**METROPOLITAN GOVERNMENT OF NASHVILLE AND DAVIDSON COUNTY**

**STAFF RECOMMENDATION**

**1423 Ordway Place**

**Application:** New construction – addition and Setback reduction

PROPOSED NEW PLAN  
 ALTERNATE  
 CONSTRUCTION

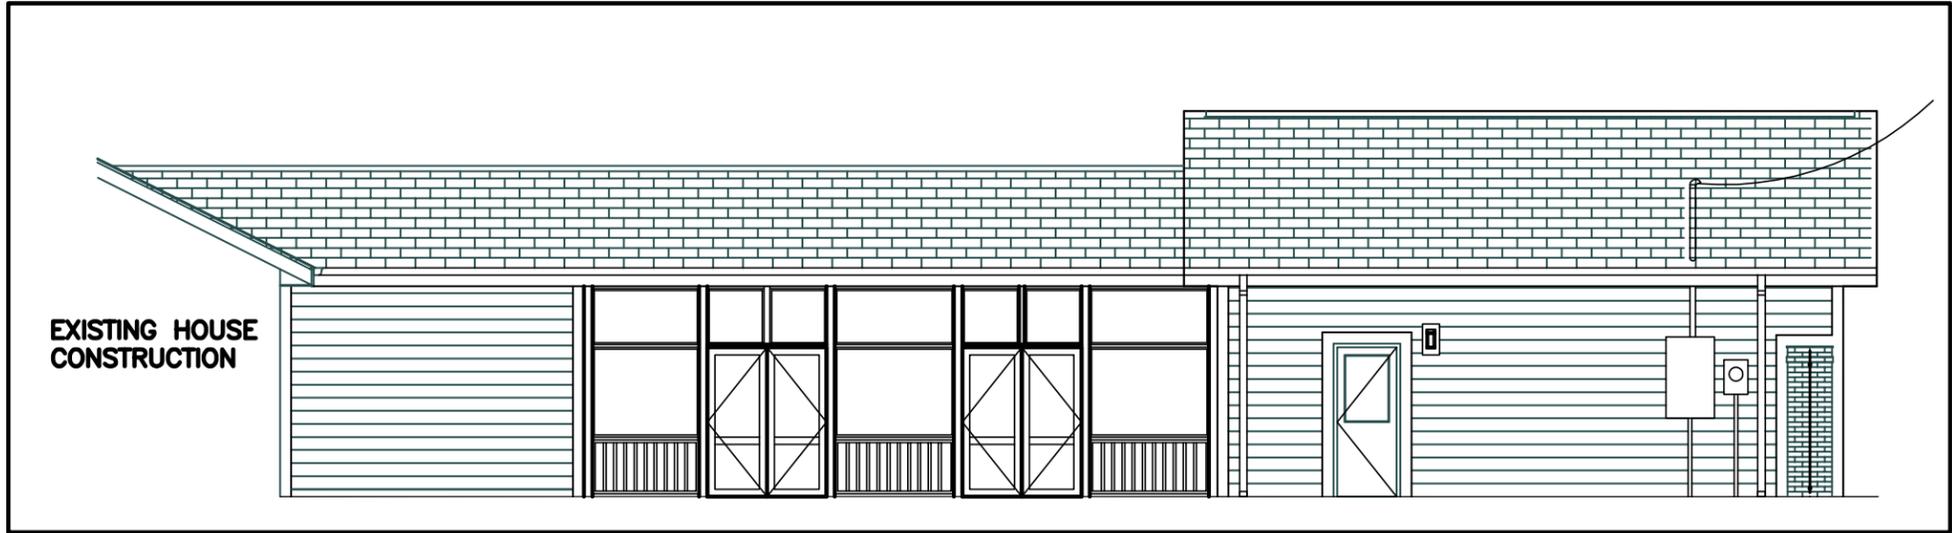
At the rear of the historic house, the applicant proposes adding a seventy foot (70’) deep addition for a mud room, screened porch and attached garage. The addition would be flush with the rear wall of the existing house, stepping out two feet (2’) to the side at a point forty-two feet (42’) back. Typically, in order to sufficiently distinguish new construction from a historic form and meet section 10.b. of the design guidelines, the Commission requires the sides of a one-story addition to set in one foot (1’) from the sides of a house, especially one that is more than approximately eight feet (8’) in depth. Although the proposed addition is deep it is also significantly narrower than the existing house, with the widest portion being at the very rear. The historic house itself is only forty-nine feet (49’) deep.

Because the addition includes an attached garage and the addition is not distinguished from the historic house with the typically required one foot (1') inset, Staff finds that the project as submitted does not meet the design guidelines for "new construction-addition" for the Lockeland Springs-East End Neighborhood Conservation Zoning Overlay. Since the addition itself does not meet the design guidelines, staff does not recommend approval of the requested setback reduction.

- the addition not include an attached garage;
- there be a minimum of ten feet (10') between the garage and the revised addition;
- the addition set in a minimum of one foot (1") on the left side;
- staff provide final approval of windows, doors and trim;
- applicant provide new drawings showing these conditions and that have the scale, major measurements and materials noted; and
- the applicant return to the Commission if these alterations require major changes that would not be administratively reviewable; otherwise allow staff to review the alterations.

NORTH ELEVATION- GARAGE FACING ALLEY

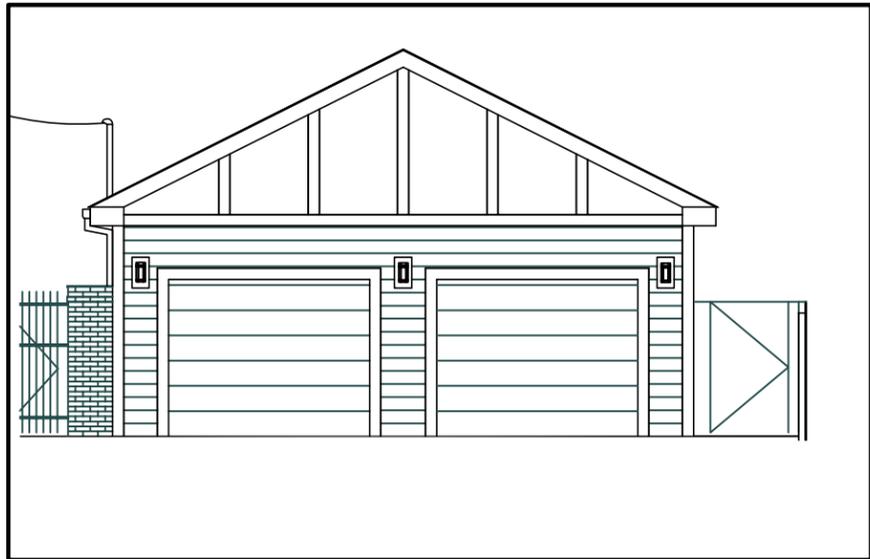
In 2011, the MHZC developed a policy on garages to provide guidance on situations where attached garages may be appropriate, based on a survey of historic garages compiled by Staff. This policy allows attached garages if they are a typical feature of the neighborhood or when the location of the attached garage is in the general location of an historic accessory building, the new garage is located in the basement level, and the vehicular access is on the rear elevation. Staff finds the proposed attached garage addition does not meet this policy and that it does not meet guideline II.B.8.

Since the conditions will require the reduction of the size of the screened porch, staff also recommends a rear setback reduction for the newly created outbuilding of up to three feet (3') from the rear alley, which should minimize the needed reduction of the rear porch. With these conditions staff finds the project meets section II.B of the design guidelines.
